**FINAL MITIGATION PLAN**  
**MIDDENDORF SPRINGS MITIGATION SITE**  
**ANSON COUNTY, NORTH CAROLINA**

DMS Project No.100151  
DWR Project No. 2020-0775v1  
NCDEQ Contract No. 8012-01  
USACE Action ID No. SAW-2021-01973

Re: NCIRT Review and USACE Approval of the NCDMS Middendorf Springs Mitigation Site /  
Anson County

Re: DMS Project ID # 100151 / Middendorf Springs Stream and Wetland Mitigation Site Mitigation Plan  
IRT Comments

C-2

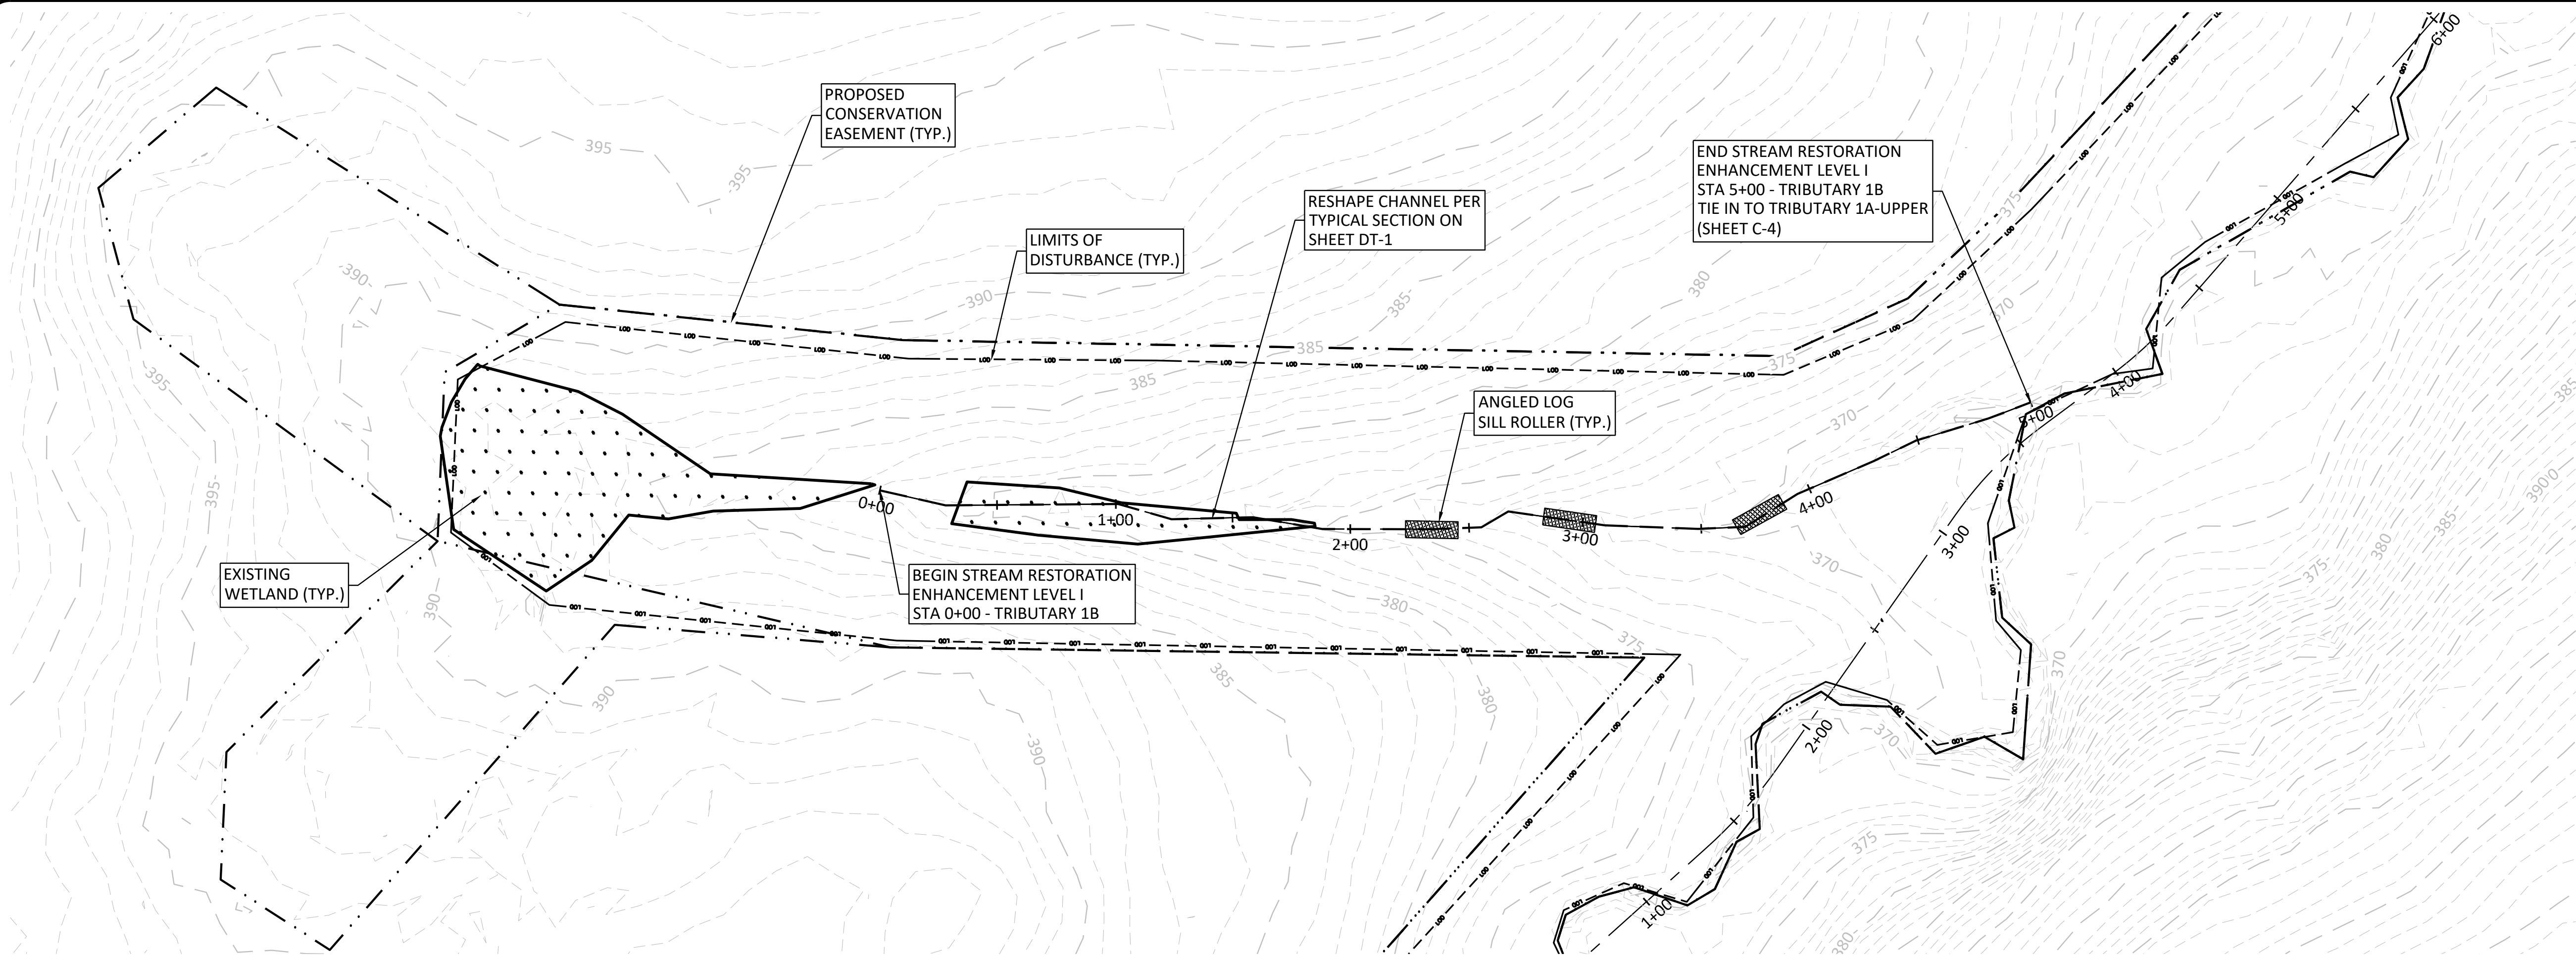
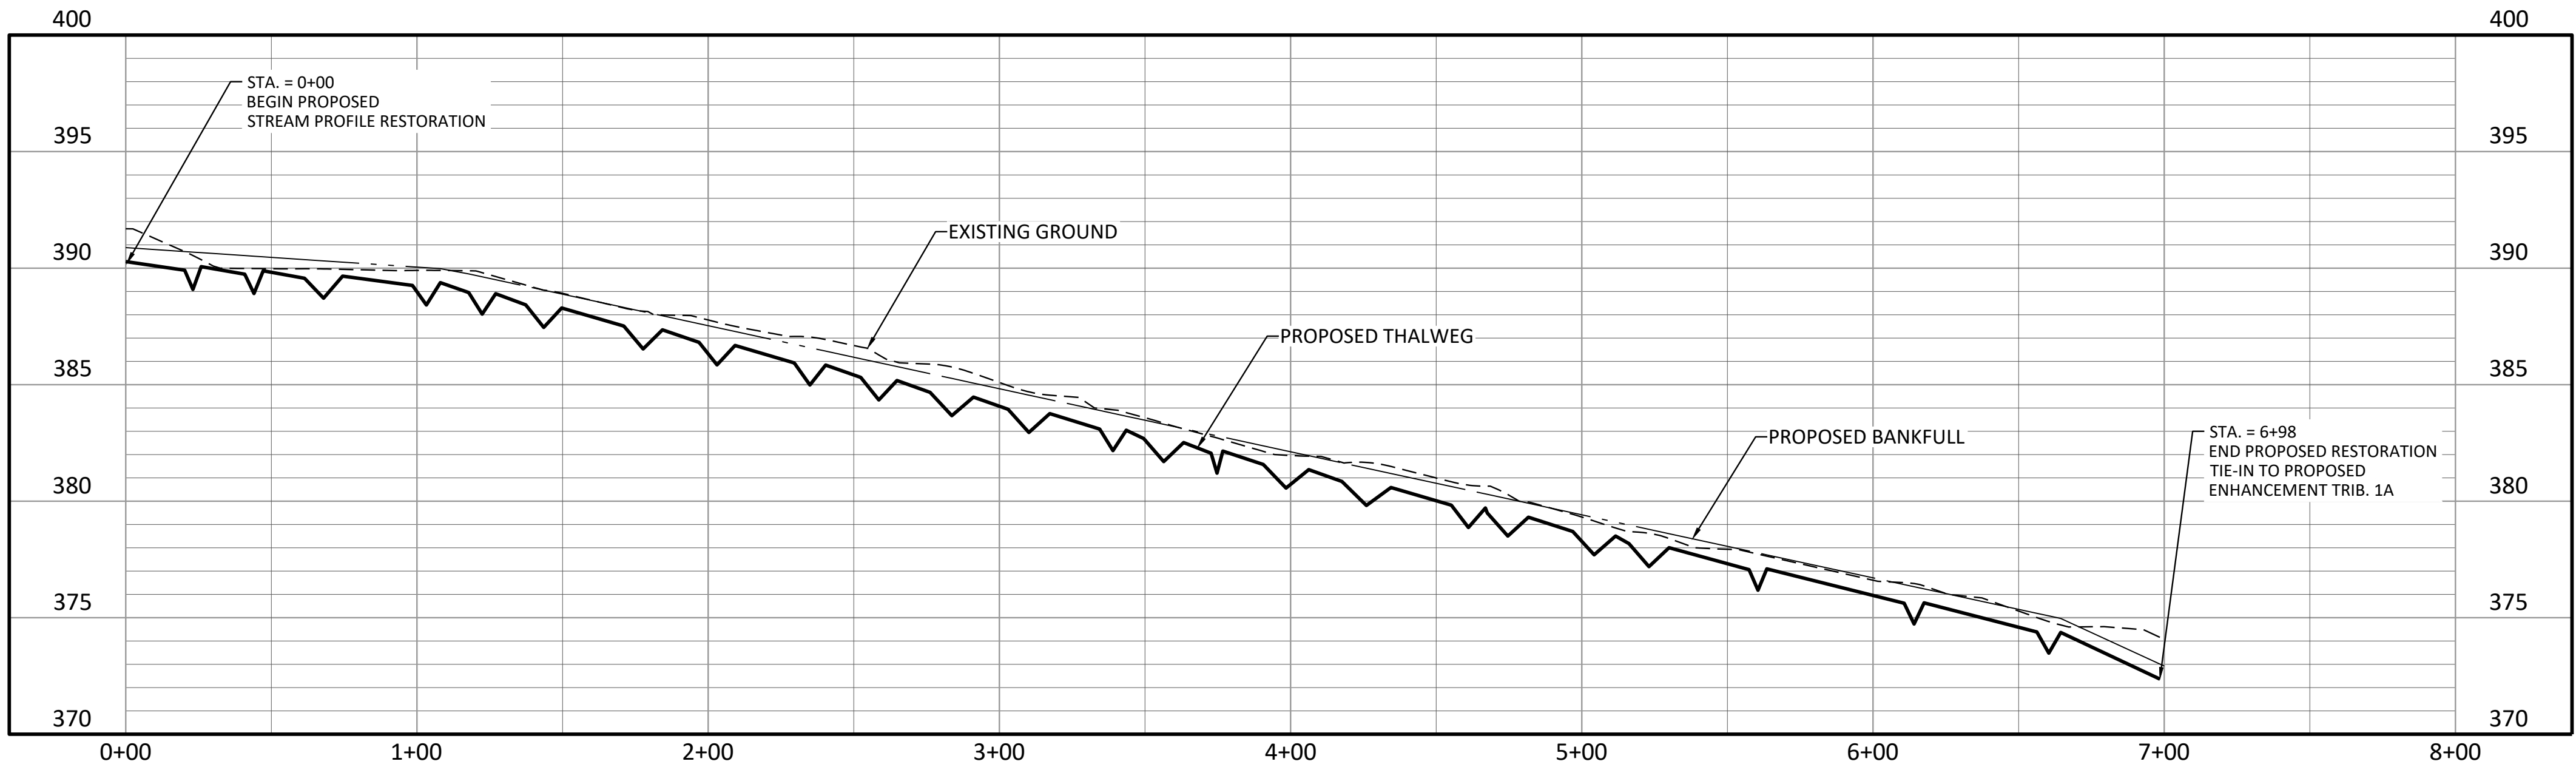
1. **DWR appreciates the review (and extensive comments) from Kelly Phillips of DMS.**
2. **DWR would like to emphasize the comment on the DMS review of Sheet C-2. DWR has concerns over the extensive use of Angled Log Sills on some of these streams with the slopes present.**

*C-2 Tributary 1C: Angled Log Sill Roller structures are shown as the only in-stream structures for most of the reach which exceeds 2% slope. The profile does not match the sequence suggested by Sheet DT-3 using the Sill Rollers which would produce a sill (step) with a pool immediately downstream. The displayed profile is more consistent with a riffle/pool sequence. Please review the plan sheet and proposed structures for consistency and applicability and add specification indicating maximum drop across an individual sill. Please evaluate this at all locations where this structure is proposed.*

We appreciate the comment. We are not concerned with the use of angled log sills as noted in the plans because we have had great success with this structure when it is being implemented by an experienced and qualified contractor and with experienced construction oversight. We have included experienced and qualified contractors as potential construction partners. Additionally, we will have qualified staff at the site, particularly during the initial in-stream construction of the logs, to ensure that the contractor understands our detail and design goals and that these structures are structurally sound upon construction with respect to detailed drop distance and installation of filter fabric to prevent undermining of the structure (as noted in comment #12).

Based on our experience with log sills, instability of the angled log sills typically occurs because the step drop is too great or there is insufficient filter fabric or filter stone behind the logs. We have added clarity to the detail to indicate that the step drop is to be 6" with an allowable tolerance up to 8".

One other issue with the extensive use of angled log sills (or any log structures) that was not mentioned in the comments is the potential for decay of the logs due to wetting and drying of the logs. Streams in the Slate Belt region are known to become dry in the summer. Thus, in the Slate Belt region there is concern that the wetting and drying of the logs would lead to a faster rate of decay than when the logs would be consistently wet. However, we are not concerned about this issue on the project for several reasons. As explained in the response to the next comment, the groundwater hydrology of the site is not typical of the Slate Belt due to the presence of the Middendorf formation at the ridgeline above the project streams, providing a more continuous supply of groundwater and baseflow from the numerous springs present across the site, which will help keep the log sills consistently wet. In addition, we have also proposed constructed riffles along with the logs sills which will provide long-term stability to the channel even if the log sills begin to decay over time.

C-3

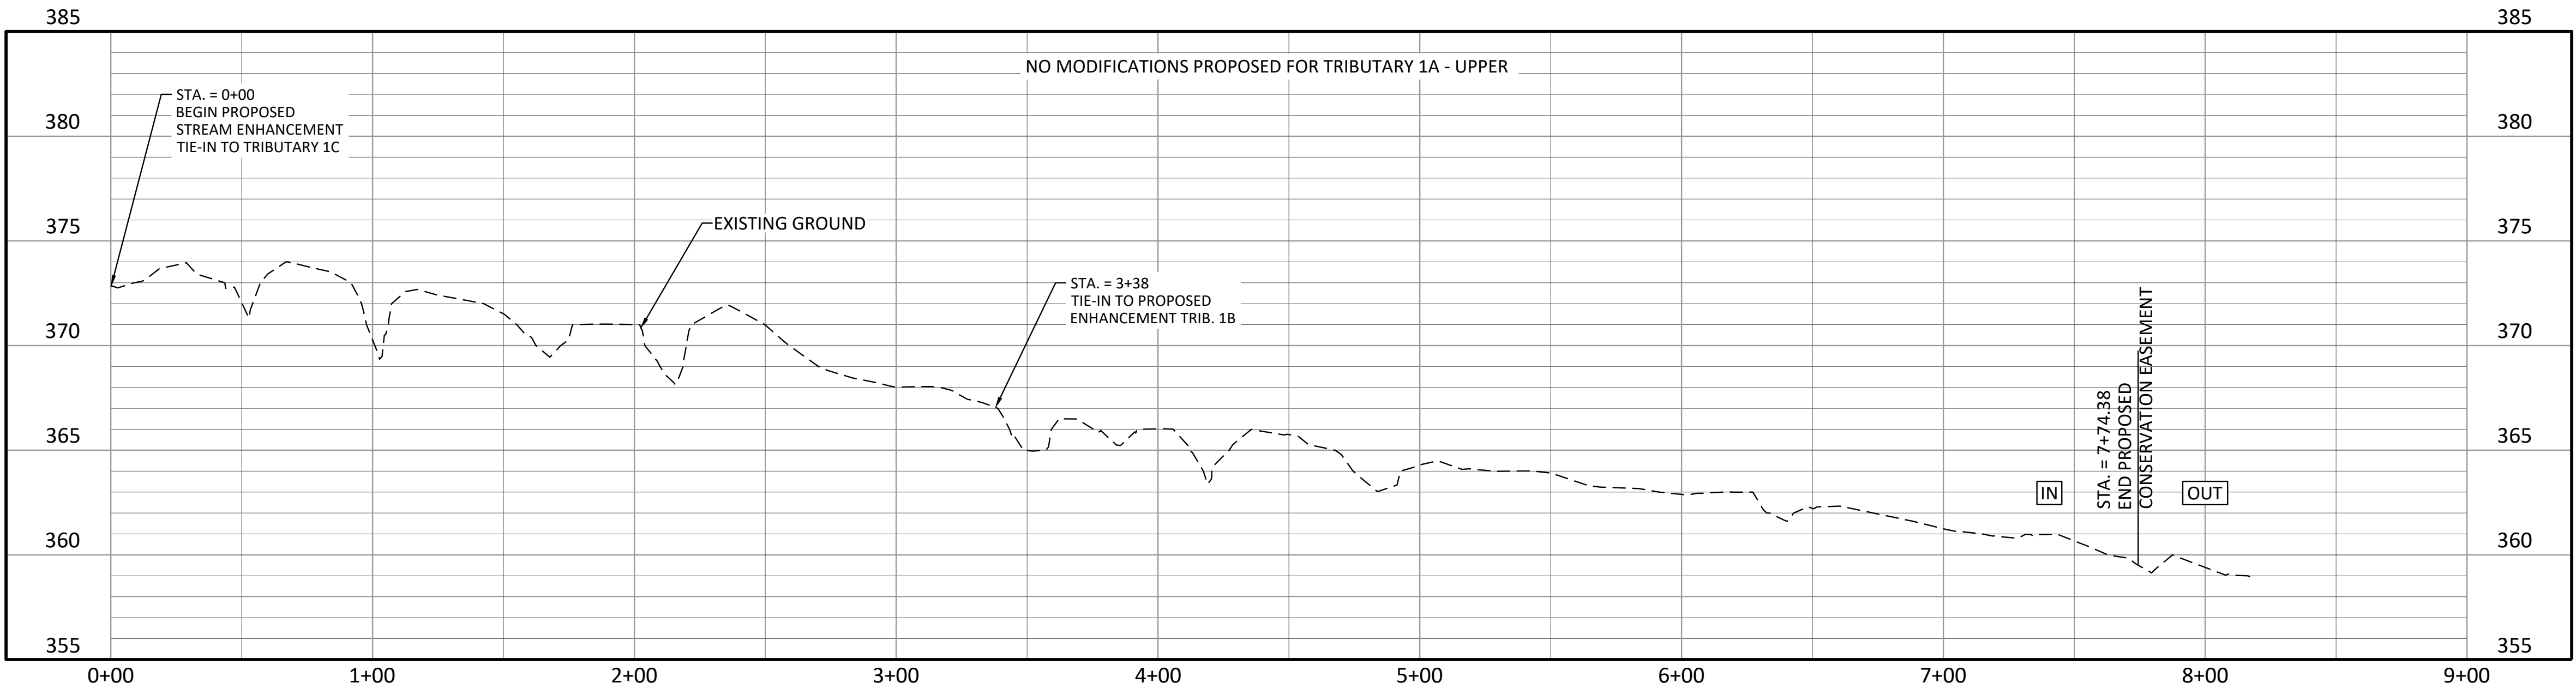
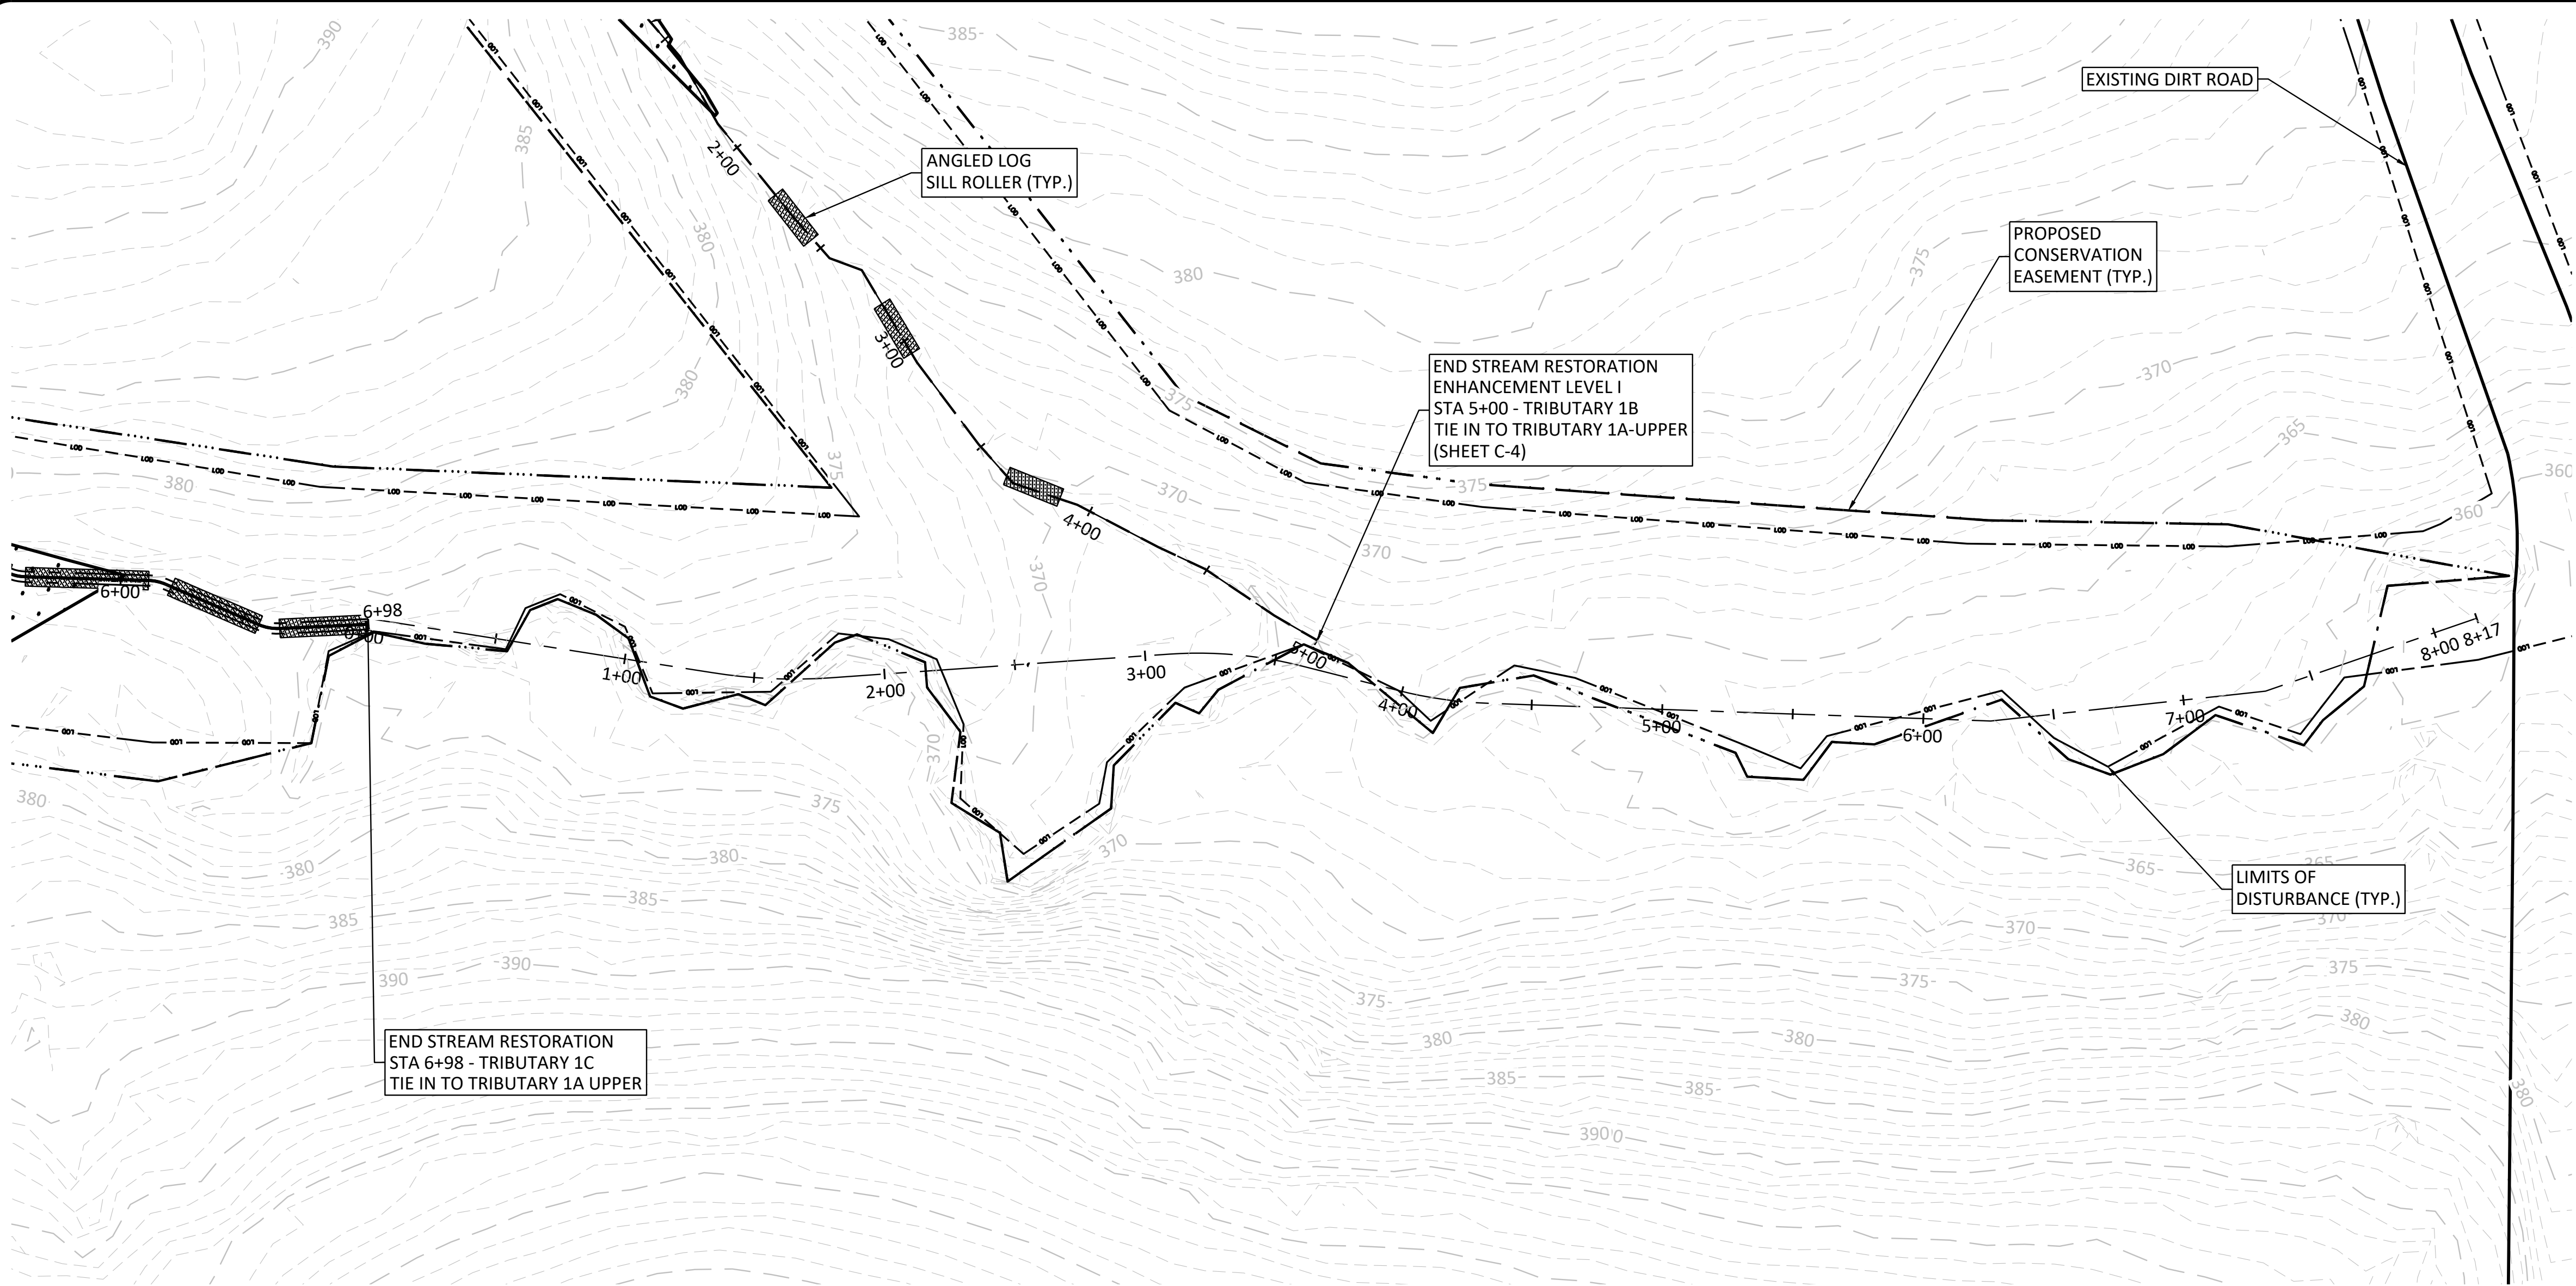
***Sheet C-3:*** Same comment as above. Why was the wetland not fully captured within the CE?

***Sheet C-3:*** Tributary 1B is shown to be 590', but Table 2 shows Tributary 1B as 500.119. Digital files show Tributary 1B beginning further downstream and for a length of 500.119". Please review and revise as necessary.
